BRE Client Report

Review of daylight and sunlight report for River Gate, 53-55 Vastern Road, Reading

Prepared for: Reading Borough Council
Date: 7 April 2020
Report Number: P117635 Issue: 1

Figure 3 51 Vastern Road approved floor plans, from drawing PDM-06 Rev C by The Keen Partnership.

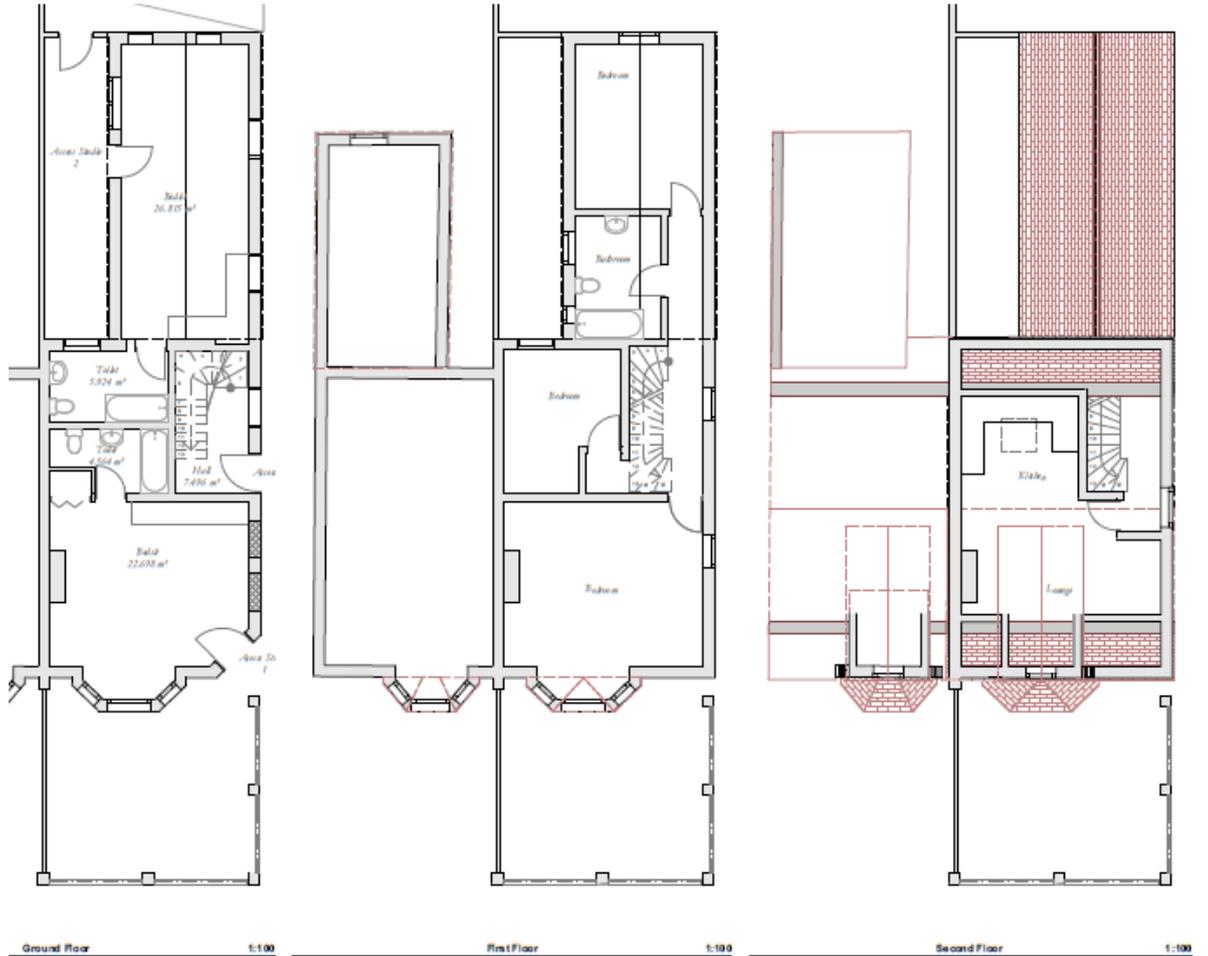
- 3.5.1 51 Vastern Road lies on the corner of Vastern Road and Lynmouth Road. Its east elevation would face block A across Lynmouth Road. Six windows in this elevation would have a loss of VSC outside the BRE guidelines, four on the ground floor, one on the first floor and one of the second floor. The losses would be minor to moderate adverse. Loss of sunlight would be within the BRE guidelines.

- 3.5.2 Valuation Office Agency records indicate that there is currently a flat on the first floor. At the time of writing there was no record of a ground floor flat and online streetview imagery shows a café on the ground floor. The recent planning history for the property includes some plans: a permitted development application reference 190692 for conversion of the upper floors to two flats and a planning application reference 191165 for conversion of the ground floor to two bedsits. The proposed room layouts for the latter are shown in Figure 3 below. The room layouts for the upper floors differ from those in the earlier permitted development application.

3.5.3 These room layouts, and the layouts in the existing plan submitted in the same application, suggest that the affected windows on the ground and first floors are either secondary windows with the main windows located on other elevations, or light stairwells. It therefore appears likely that none of the affected windows are covered by the BRE guidelines.

Figure 6 Block BC ground floor, ADF failures marked.

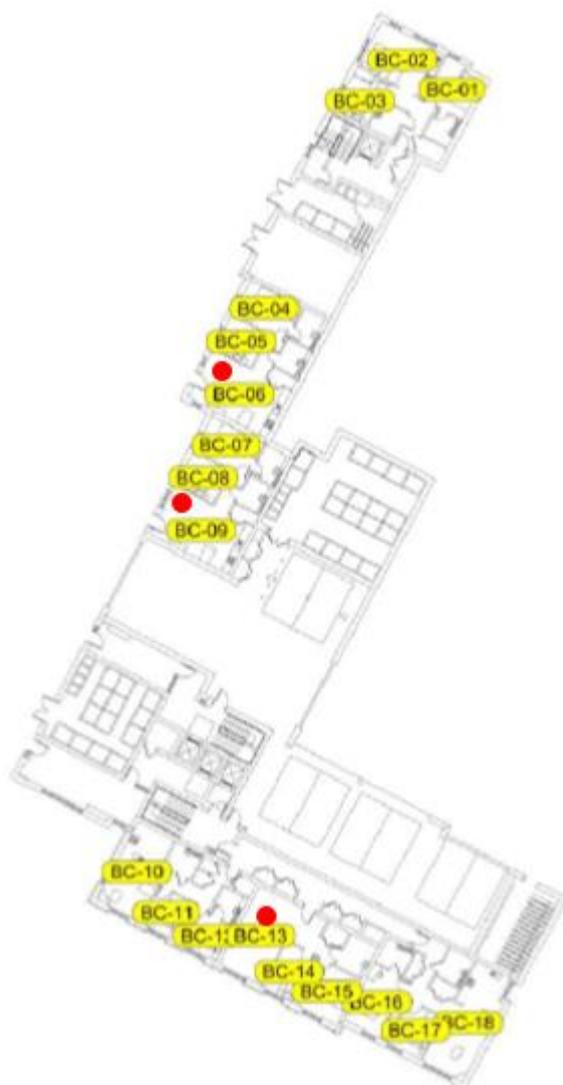
4.3.1 Seven living rooms on the ground and first floors of this block would not receive the recommended amount of daylight. Some of them would have extremely low ADFs. They are shown in Figure 6 and Figure 7 and considered individually below.

- 4.3.2 Living room BC-06 on the ground floor faces north west. It would have an extremely low ADF of 0.3%, where the recommended minimum for living rooms is 1.5%. This room would be very gloomy and need supplementary electric lighting almost all the time. Daylight provision to this room should be improved if at all possible. The equivalent room on the first floor would be better but would still fall well short at 1.0%. The main windows face the terrace of two storey houses on Lynmouth Road, and would therefore not be particularly obstructed externally; their poor levels of daylighting are therefore a consequence of their own design and the equivalent rooms on upper floors may well have the same issue. In particular, the ground floor room has a much narrower main window than the first floor room and has the potential for improvement subject to other site design factors. They both appear to have the potential for increased window area in their side elevation.

4.3.3 Living room BC-09, also on the ground floor and facing north-west, has a low ADF of 0.9%. This room is large for its window area. There appears to be some limited potential to increase window area but it is unlikely to be possible to bring this room up to a pass without loss of room area.

Figure 7 Block BC first floor, ADF failures marked

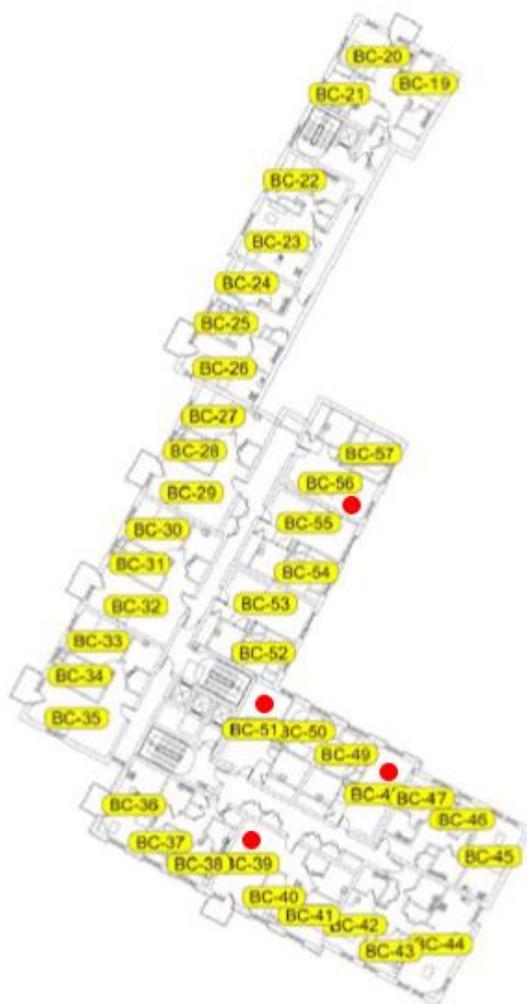
4.3.4 Living rooms BC-13 on the ground floor and BC-39 on the first floor face south west. BC-13 would have an ADF just below the recommended minimum for living rooms at 1.4%. BC-39 would be a lot lower at 0.8%. It has a large floor area for its window size, but it does have the compensatory benefit of private amenity space. These rooms are potentially vulnerable to loss of daylight due to the future development of Vastern retail park, but less so than the equivalent rooms under balconies in Block A as the retail park site is slightly to one side and block BC faces Station Shopping Park.

4.3.5 Living room BC-48 faces north east. It is important that north facing rooms are well lit as they will not have the benefit of sunlight in that position. The room has an ADF of 1.4%, just below the recommended minimum for living rooms. It does not have an overhead balcony limiting its overhead daylight, and so it does not have the compensatory benefit of private amenity space.

There is the potential for this window to be widened, particularly as it does not face south and will be less prone to overheating.

- 4.3.6 Room BC-51 also faces north east. It would have a very low ADF of 0.6%. It is set in the corner of the building so that the window is substantially obstructed to one side and the window is very small. There would be no compensatory outdoor benefit such as a balcony, and it would not receive any sunlight, so it would be a very gloomy space. The design has placed a large room with the greatest need for daylight in a position where it will receive the least. The result for this room should be improved if at all possible by altering the layout. Bedrooms are a better choice for building positions with limited prospect for daylight. On the higher floors, this location is occupied by a bedroom.

- 4.3.7 Room BC-56 would face south east. It would have an ADF of 1.2%, below the recommended value for living rooms. This room would have a reduced level of daylight, but without the compensatory benefit of private amenity space. It would receive the recommended amount of sunlight. Subject to other site design factors, there appears to be the potential to increase the size of this window.

Figure 8 Block EFG ground floor, ADF (red) and sunlight (green) failures marked.

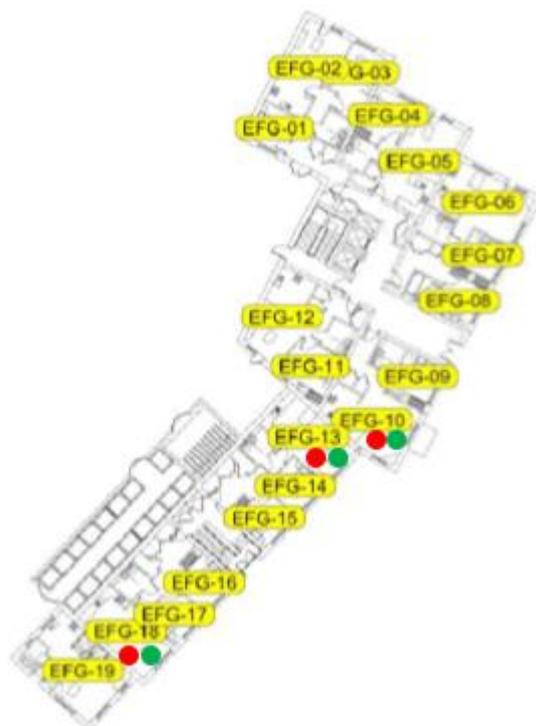
- 4.5.2 Three ground floor rooms in this block, marked in Figure 8 below, would not receive enough of either daylight or sunlight. The individual rooms are discussed below.

- 4.5.3 Living room EFG-10 is dual aspect. It has a main window facing south east which is located underneath a balcony and a secondary window facing south west. It would have an ADF of 1.4%, just below the recommended amount for living rooms. It would receive the recommended amount of year round sunlight, but would receive just below the recommended amount of winter sunlight. The sunlight would be difficult to change due to the other buildings in the development presenting an obstruction to the south and east, and year round sunlight is more important. However, subject to other site design factors, the ADF could potentially be improved by increasing the glazing area.

- 4.5.4 Living room EFG-13 faces south east. It would be extremely poorly daylit. It is a large room for the size of its window and it would have an ADF of 0.3% against a recommended minimum for living rooms of 1.5%. It would also receive almost no sunlight, 3% of annual probable sunlight hours against a recommended minimum of 25%, and 2% of winter sunlight hours against a recommended minimum of 5%. It would be a very gloomy room which would need supplementary lighting almost all of the time. On higher floors, the rooms in the same position don't have the same problem as there is another window to the rear of the room. Daylight to this room should be improved if at all possible. It would be difficult to improve the amount of sunlight it receives as sunlight is obstructed by the other blocks of the development. This makes reasonable daylight provision even more important.

- 4.5.5 Living room EFG-18 also faces south east. It would have an ADF of 0.6% against a recommended minimum of 1.5% for living rooms. The room is large for its window size. There appears to be some limited potential for increased window area, but it is probably not possible to bring the daylight up to a pass without losing floor area or making very large changes to the design of the scheme. The window would also fall substantially short of the sunlight requirement, receiving 5% of APSH against a recommended minimum of 25%. Winter sunlight would be better, and only slightly below the recommended minimum.

- 4.5.6 We disagree that the very poor results should be accepted as isolated deviations and suggest that the design should be revisited to see if their daylight and sunlight provision can be improved any further. The fact that other homes in the development would be better daylit would not provide any comfort to the people who live in the very poorly lit properties. In particular, 0.3% is an exceptionally low ADF which will provide very poor living conditions.
